**YESLER TERRACE
BLOCK 5 | BLDG B**

EAST DESIGN REVIEW BOARD

DESIGN RECOMMENDATION MEETING

1020 S MAIN ST | PROJECT #3028954

LEVEL 1 COURTYARD PLAN ①

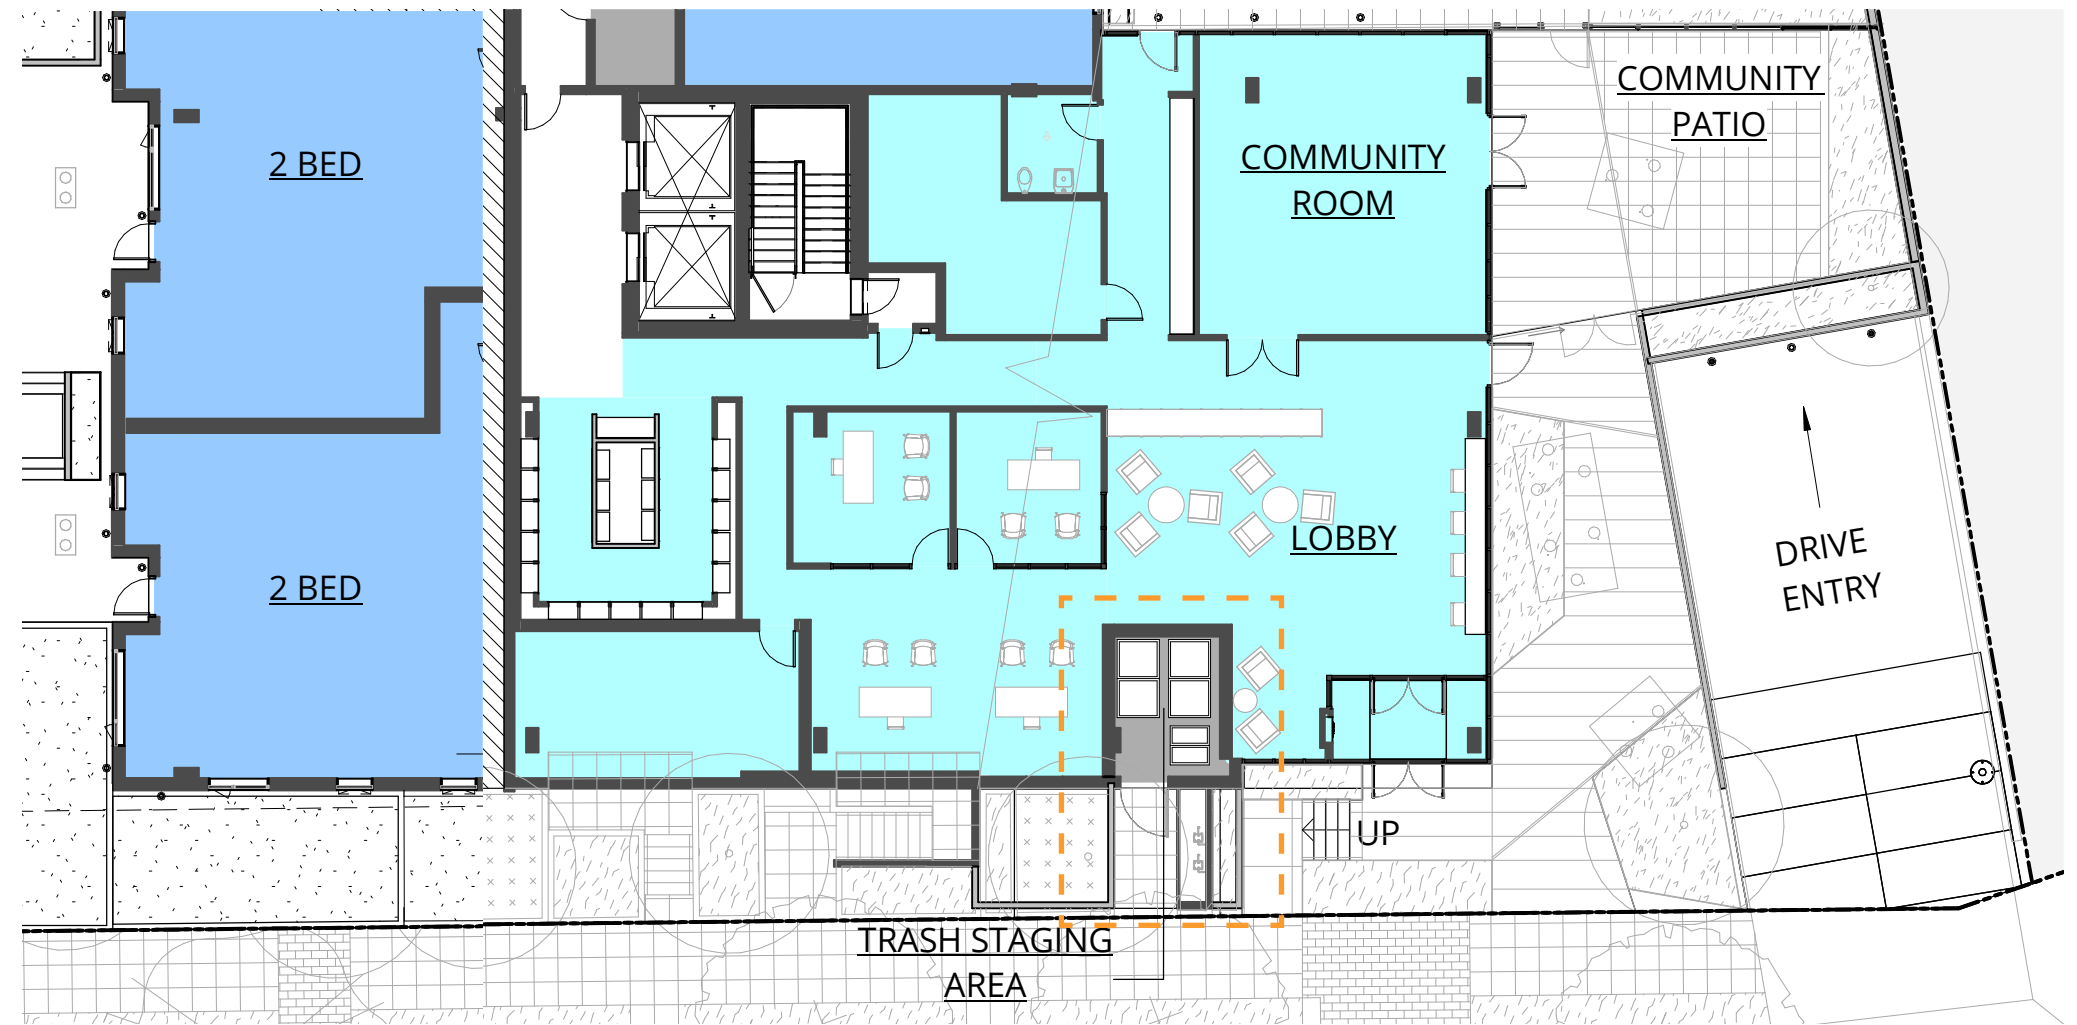
During the Design Review Recommendation of Building A, the Board recommended that the outdoor trash staging area be relocated internally to avoid staging at the street and/or provide greater screening along the street. We have continued this approach to Building B but unfortunately the grades are much steep at B limits our possible locations.

Building B takes a similar approach to Building A where the trash staging area is located next to the residential lobby. In Building B, it is tucked away discreetly between a planter and a pocket wall for the screened gas meter.

Other locations were considered but found impractical. Along S. Main Street next to the residential units is not feasible because of steeper grades and proximity to the Pocket Park. Aesthetically, it would reduce glazing and eyes on the street, breaking the massing of the building at this corner.

WOODTONE PRODUCT USED AT THE ELEANOR APARTMENTS, RAVENNA

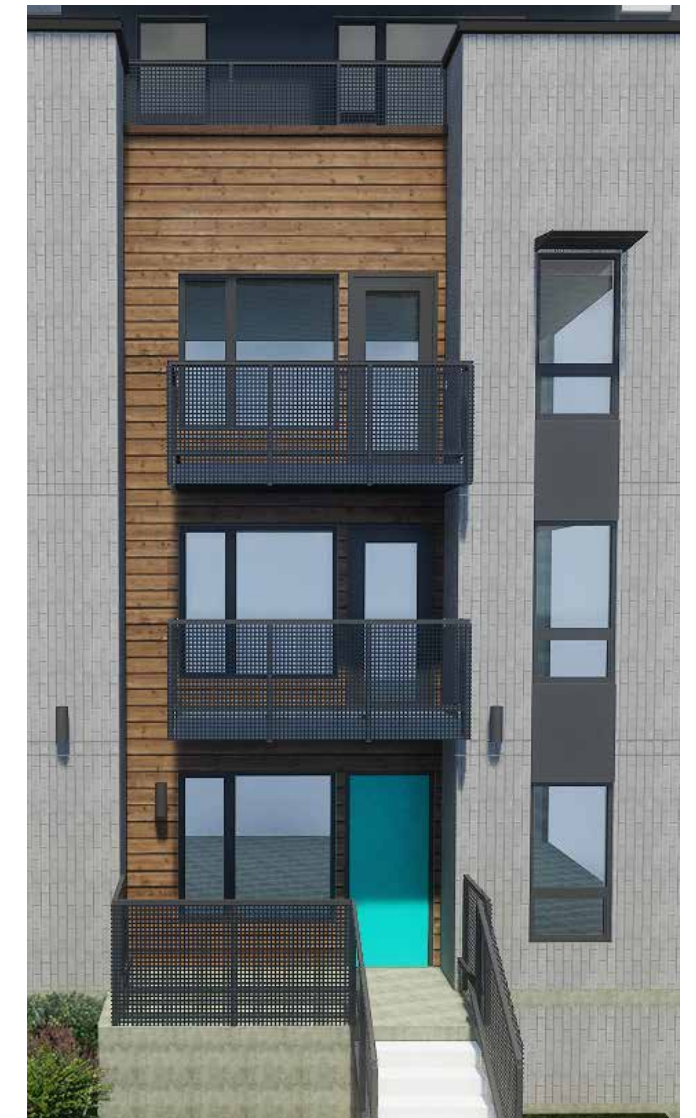
a. Although the Board approved of the design intent, the Board observed the large amount of fiber cement proposed and noted the range of quality between fiber cement panel products. The Board indicated cladding that would be acceptable that includes a thicker panel depth and potentially integral color. The Board agreed samples were needed to determine if the wood-look fiber cement panel would qualify as a higher quality material, consistent with the Yesler Terrace Design Guidelines and requested photographs of built precedents.

b. The Board was concerned with the detailing of the wood-look fiber cement panel in the vertical orientation.

Buildings A and B maintain a coherent design. Each building is unique by itself but belongs to the same family. This will be achieved by applying similar/same materials but with different details, different proportion/scale of materials, patterns, accent colors, brick modules etc. Facades and materials of Buildings A/B will be designed holistically so that they are interconnected, yet unique. Like materials will no longer be touching between Buildings A/B, minimizing the material time-gap issue. Although this site is not located along *build-to line* or *reduced setback area* standard facades and not required to provide preferred materials at all heights of facades, all street-level facades in Building B maintain 70%+ preferred materials.
